To : Advisory Committee on Nuclear Waste  
Nuclear Regulatory Commission

FROM : H.B. Krauskopf  
Stanford University

SUBJECT: Review of DOE Study Plan on Water Movement Tests

Figure 14.--Generalized section across Yucca Mountain showing flow regime under baseline conditions. Lengths of solid arrows show relative magnitude of fluxes.

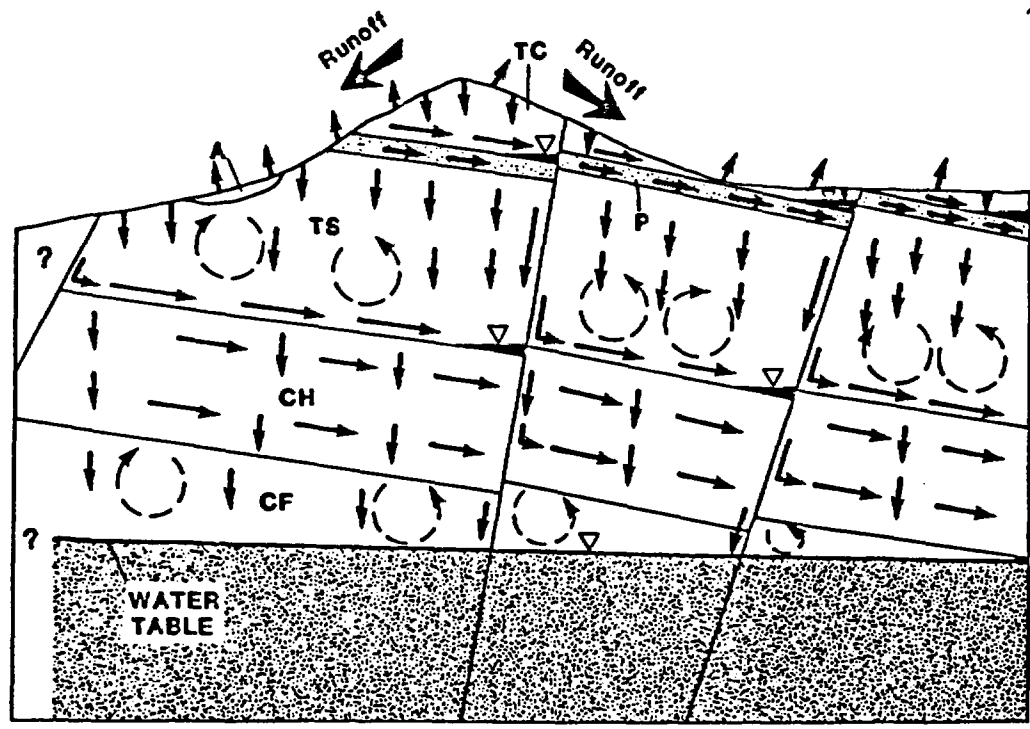
The sketch on page 3, reproduced from Montazer and Wilson (1984), shows the many possible complications in water movement thru tilted and faulted layers of tuff. The many places where old water could be retained for long periods, and where younger water could mix with it or move under it, are evident from the indicated flow paths. The possibilities seem so numerous and so unpredictable that one can fairly ask whether the  $^{36}\text{Cl}$  method, or any method of determining water ages on isolated samples, can give an interpretable picture of water movement. The flow paths on the diagram, of course, are only conjectural, based on general rules of groundwater movement and the properties of the different tuff layers; it is possible that actual movement for the most part follows simpler downward paths, so that water ages might have more obvious meaning. It seems to me that this possibility is great enough so that DOE's proposed measurements should be tried.
